**ADDENDUM NO. 1  
TO  
PROPOSAL AND CONTRACT DOCUMENTS  
COBB COUNTY AIRPORT – MCCOLLUM FIELD  
KENNESAW, GEORGIA  
SOUTH TAXIWAY & SOUTH APRON IMPROVEMENTS  
GDOT No.: APXXX-XXXX-XX(067) COBB**

**PROJECT: COBB COUNTY AIRPORT  
SOUTH TAXIWAY & SOUTH APRON IMPROVEMENTS  
COBB COUNTY BID NO. 10-5502  
APXXX-XXXX-XX(067) COBB**

**TIE DOWN DETAIL**  
N.T.S.

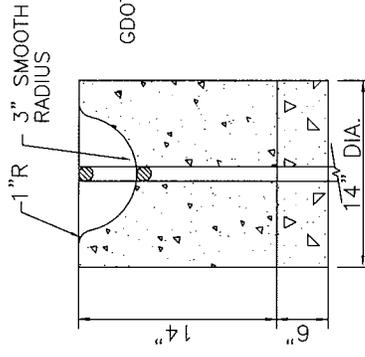
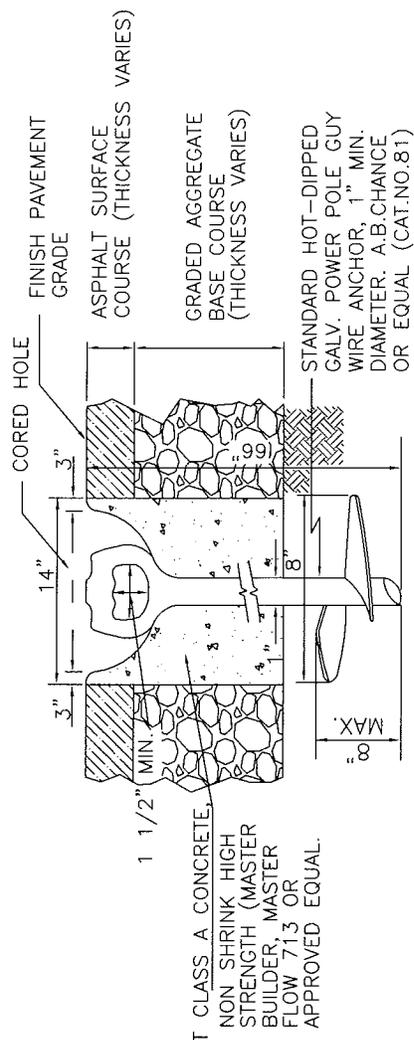
- 3) Drawing MP-1 – It is clarified that aircraft tie-downs are required for the Phase 3 work and will be paid for under Item P-621A. A tie-down detail has been included as an attachment to this Addendum.
